Access Compliance Report

Public Rights-of-Way

(Curb Ramps)

Intersection ID: N/A	Main Street: KELBURN_LN	Cross Street: N/A	Location: E
ADA ID: 249B1DC7C675	Ramp Type: Perp	Initial Pass/Fail: Fail	Overall Compliance: No
		Severity Score: 10

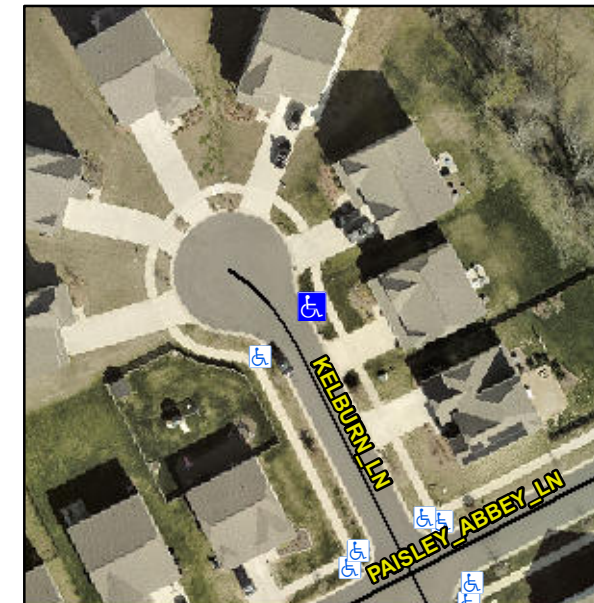
R304.5.1, R304.5.3

Compliance	Description	Data	Compliance	Description	Data
N/A	Ramp Length (in)	96.0	Yes	Ramp Slope (%)	5.6
No	Ramp Width (in)	46.5	No	Ramp XSlope (%)	3.6
N/A	Flare Type LT	N/A	N/A	Flare Type RT	N/A
N/A	Flare Slope LT (%)	N/A	N/A	Flare Slope RT (%)	N/A
N/A	Flare Traversable LT?	N/A	N/A	Flare Traversable RT?	N/A
N/A	Landing Length (in)	N/A	N/A	DWS Provided?	N/A
N/A	Landing Width (in)	N/A	N/A	DWS Contrast?	N/A
N/A	Landing Slope (%)	N/A	N/A	DWS Length (in)	N/A
N/A	Landing X Slope (%)	N/A	N/A	DWS Full Width?	N/A
N/A	Landing Curb? (Y/N)	N/A	N/A	DWS Offset (in)	N/A
N/A	Shared Landing?	N/A			
N/A	Gutter Ponding?	N/A	N/A	Gutter Slope (%)	N/A
N/A	Gutter Lip Ht (in)	N/A	N/A	Gutter X Slope (%)	N/A
N/A	Painted X Walk1?	No	N/A	Painted X Walk2?	N/A
	X Walk 1 Direction	To SW		X Walk 2 Direction	N/A
N/A	X Walk 1 Width (in)	N/A	N/A	X Walk 2 Width (in)	N/A
	X Walk 1 Slope (%)	4.3		X Walk 2 Slope (%)	N/A
	X Walk 1 X Slope (%)	2.0		X Walk 2 X Slope (%)	N/A

Remove & Replace Entire Ramp.
